## 01-416 Modifications to precombustion chambers

### Precombustion chamber combustion bore pattern modified

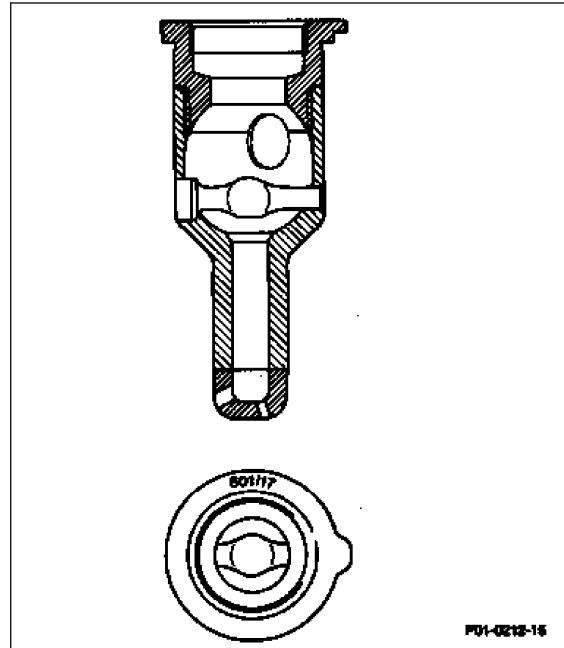
As of 06/86 the combustion bore pattern of the precombustion chambers was modified to improve combustion on engines 601.91, 602.91 and 603.91.

Modified precombustion chambers are marked with the code number 601/17.

### Collar height on upper section of precombustion chamber increased

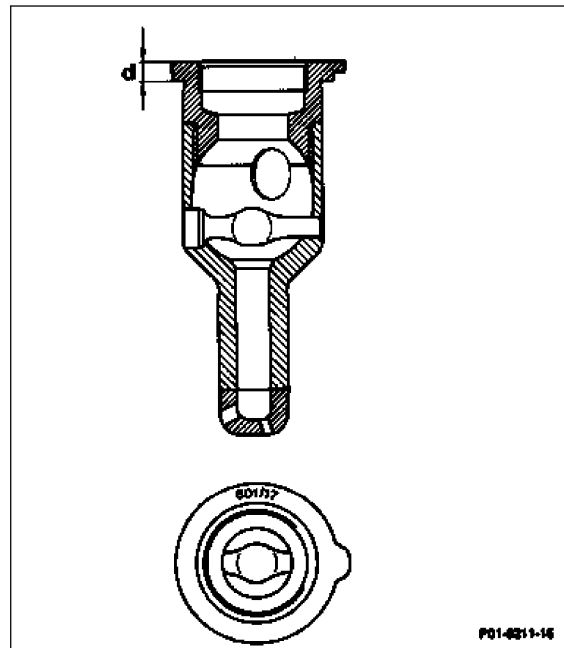
As of 09/87 the collar height (d) on the upper section of the precombustion chamber on engines 601.91, 602.91, 603.91 and 603.96 was increased from 5 mm to 6 mm.

Engines 601.91 (CH) and 602.96 with angular injection are not affected by this modification.

### Shape of prechambers

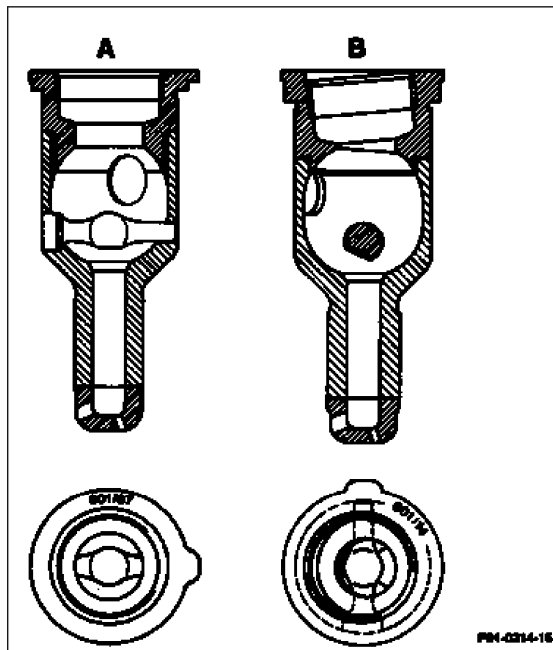
The shape and design of the precombustion chambers has been changed in the course of improving the emissions (exhaust gas recirculation).

The installation bore was inclined  $5^\circ$  to the longitudinal axis of the precombustion chamber. This results in the injection nozzles injecting the fuel into the precombustion chamber at a slight angle rather than vertically.

### Peculiarities of precombustion chambers

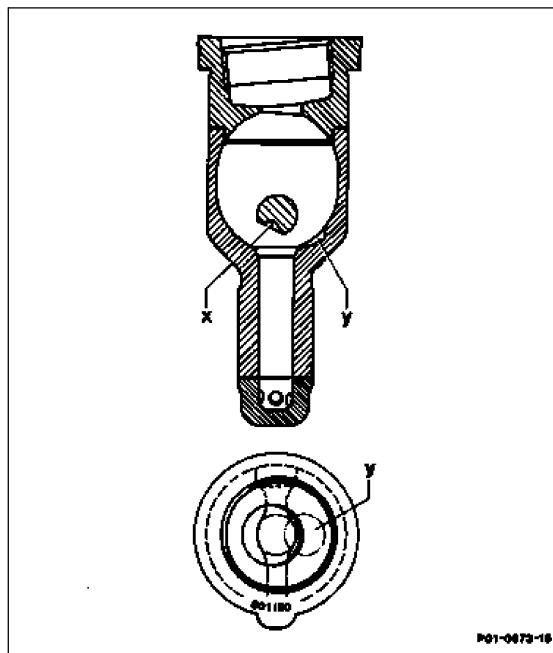
The insert pin is produced using a heat-resistant material (Incoloy) due to the higher thermal load. A cone (x) on the insert pin and a recess (y) at the bottom of the precombustion chamber serve to give the air/fuel mixture a better swirl. Moreover the volume of the precombustion chambers on engines 603.962 and 603.90 (USA) was increased from 10.34 cm<sup>3</sup> to 11.37 cm<sup>3</sup>.

### Installation of nozzle holder

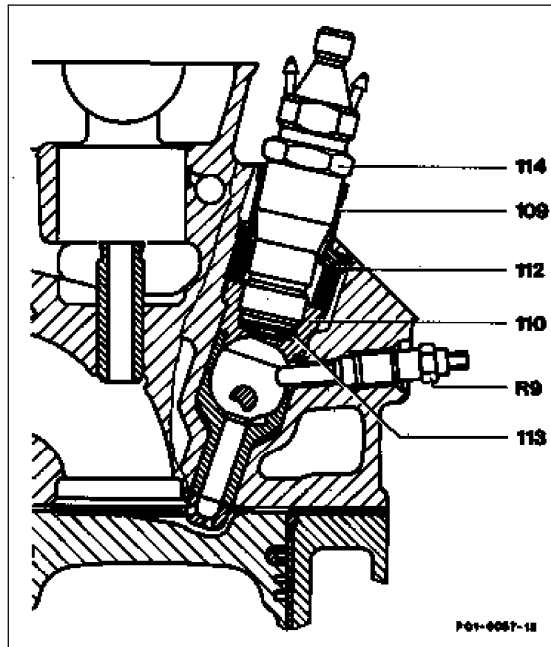
For angular injection the nozzle holder (114) is inserted into the upper section of the pre-combustion chamber turned 180° in relation to the previous position. A threaded ring (112) with inner splines serves for installing the nozzle holder.

A sealing sleeve (109) is located in the gap between the threaded ring and nozzle holder to protect against contamination (discontinued as of 08/93)

### Threaded ring for holding nozzle holder

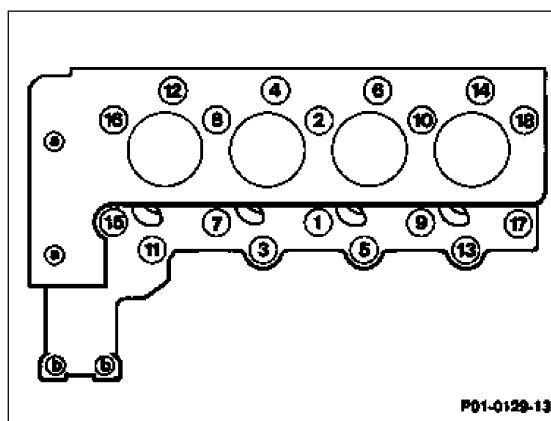
The threaded ring used for angular injection is equipped with inner splines.

The groove for a pin wrench present on the threaded ring for vertical injection is no longer present.

The splined wrench 603 589 00 09 00 is required for removal and installation of the threaded ring with inner splines.

### Precombustion chambers turned 180°

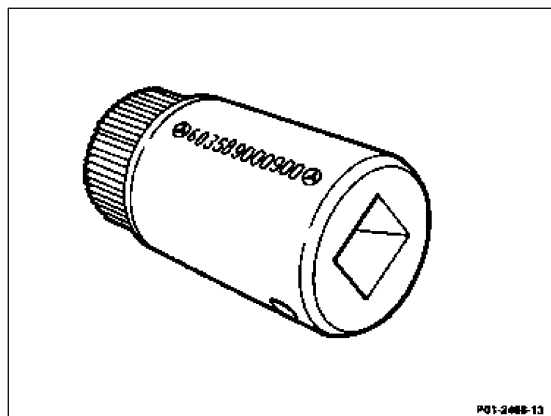
Due to other modifications to the nozzle holder combination in relation to the precombustion chamber longitudinal axis the former is inclined at an angle of 5° and installed in the upper section of the precombustion chamber turned 180°.

Differences in precombustion chambers

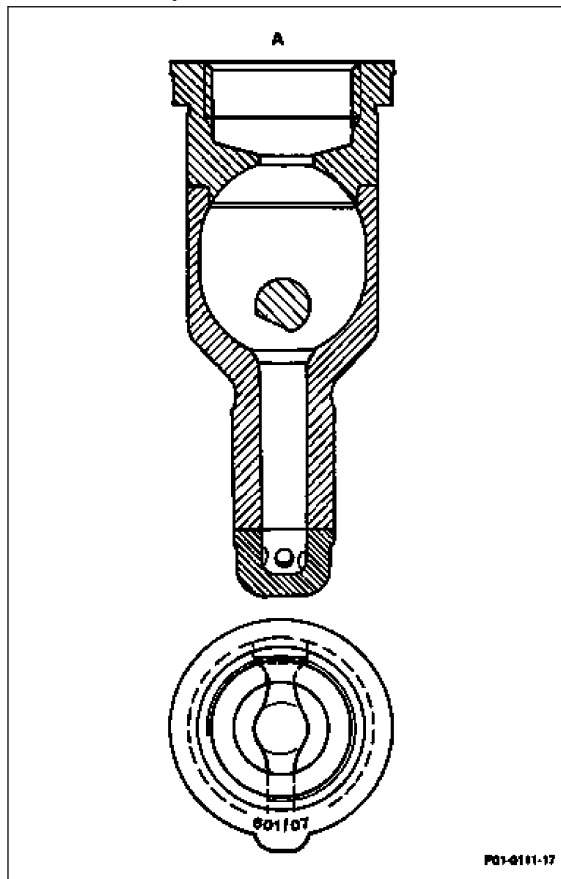
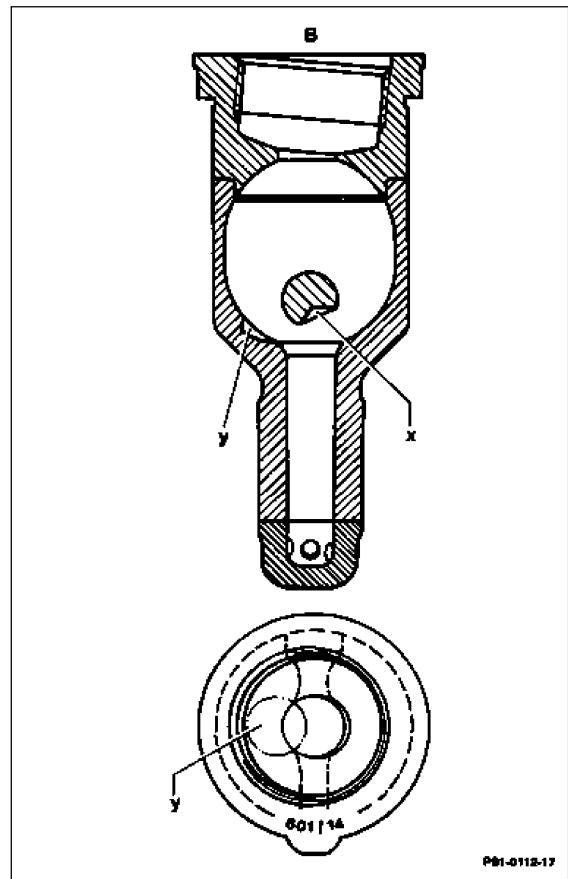
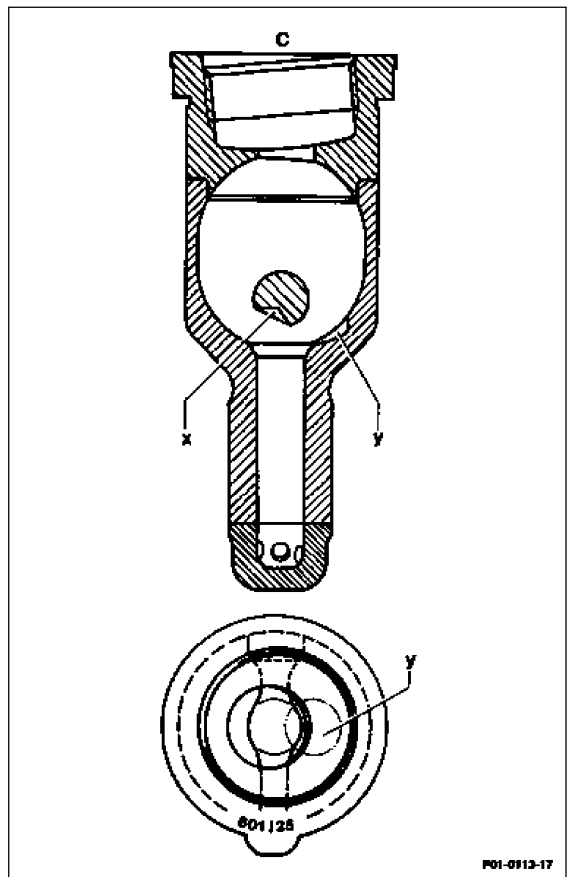
- A Code 601/07 or 17/09 or 23
- B Code 601/14/15 5° inclined (engine 601.91 as of 10/87 <sup>CH</sup>)
- C Code 601/25/26/30/36 5° inclined, turned 180° (all engines as of 06/88)
